This document contains FAQs that were approved since the last revision of NEI 99-02. The following table has the most recently approved FAQs toward the top of the list.

Database #	FAQ #	PI	Site-Specific or Generic	Subject	Effective Date
TBD	13-01	IE01	Specific (Turkey Point 3)	Exemption Request from Green-White Threshold	06/26/2013
TBD	12-06	EP02	Generic	DEP Opportunities	07/01/2013
N/A (withdrawn)	12-05	MS05	Generic	Safety System Functional Failures	N/A
TBD	12-04	OR01	Generic	HRA Related Occurrences	05/08/2013
TBD	12-03	IE04	St. Lucie 1	Unplanned Scram with Complications definition and exemption request	10/01/2012
TBD	12-02	PP01	Generic	Compensatory Hours for Perimeter Intrusion Detection System	10/01/2012
N/A (withdrawn)	12-01	MS06	Columbia	EDG Failure	N/A
TBD	11-13	EP03	Generic	Suspension of siren testing for weather-related issues	04/01/2012
TBD	11-12	IE03	FitzPatrick	Condenser Fouling	01/19/2012
TBD	11-10	PP01	Site-Specific	Compensatory Hours (Not publicly available. Contact the NEI or NRC ROPWG representative for additional information)	01/19/2012
N/A (withdrawn)	11-09	IE04 MSPI	Crystal River 3	Extended Shutdown	N/A

Diagram 1: Low flow area with debris build-up behind Boot

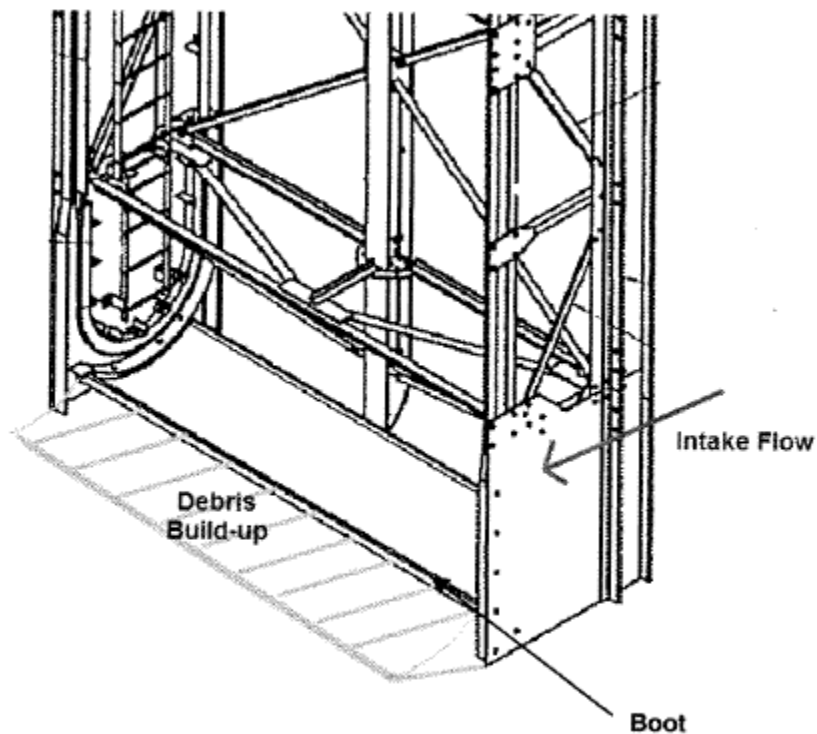
boot. There is a possibility for small debris such as silt, sand, and broken zebra mussel shells to settle in this area south of the screens (pump suction side). In this area, the silt may settle out past the boots and build up to a level to meet up with the process flow. This condition would only take a short period of time to build-up and then would remain in the condition until cleaning could remove the debris.

During normal operation, this debris build-up is not a significant threat to fouling because the debris is settled. However, this area becomes vulnerable when the gates are installed because of the change in flow patterns and increased velocity.

These downpower events should be excluded from the indicator. The licensee had experienced condenser fouling with the original traveling water screen design and although the travelling water screens had been replaced with a new design that previous operating experience was considered in planning the work on the new screens. The licensee took reasonable steps to prevent intrusion by cleaning the forebays and provided normal operating procedural guidance for monitoring condenser differential temperatures and backwashing the condenser water boxes. Since this was the first time the boot inspections had been performed, there was no way to reasonably anticipate that the debris south of the travelling water screens would have been sufficient to cause the observed condenser fouling. In addition, the on-line schedule for that week had a contingency action to perform a downpower in order to support backwashing activities. This was shown as a contingency because there is no way to accurately predict if the condenser will foul or the speed with which it will reach a point requiring a downpower.

**Figure 1, Load and current profile during DG3 Operation on 2/28/10**

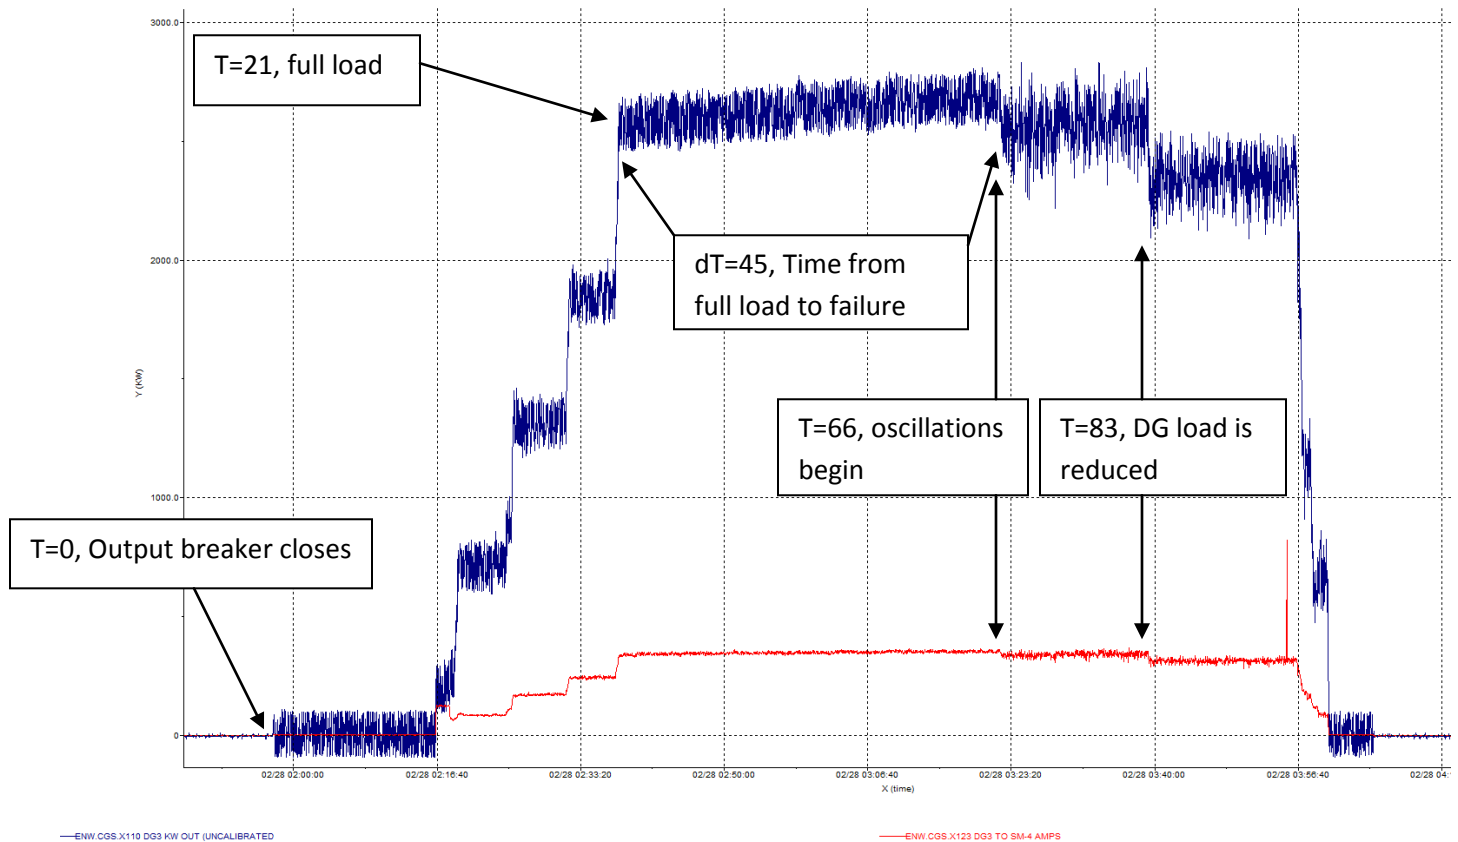
The NRC staff evaluated this issue based on the characteristics of the EDG failure (i.e., the functional response of the EDG and the failure mechanism), and applying reasonable decision-making using the guidance in effect at the time of the failure. The oscillations were caused by foreign material in the governor – a condition that had existed for several years and that did not impact prior breaker closure and sequencing operations. Figure 1 in this FAQ shows that the oscillations did not occur during the breaker closure or the load sequencing or gradual loading action. Rather, the oscillations occurred 66 minutes after breaker closure and 45 minutes after the full load (for purposes of the test run) was achieved, which is indicative of a challenge to the EDG’s ability to continue to run for its mission time. Even though the foreign material existed in the governor for several years, the EDG had started and load sequenced several times without failure. Therefore, this failure appears to have been exacerbated by the running (vice start or loading) of the EDG.

Because Figure 1 data is more reflective of an EDG failure-to-run for its mission time rather than a loading failure, the EDG failure at Columbia should have been reported as a failure-to-run.
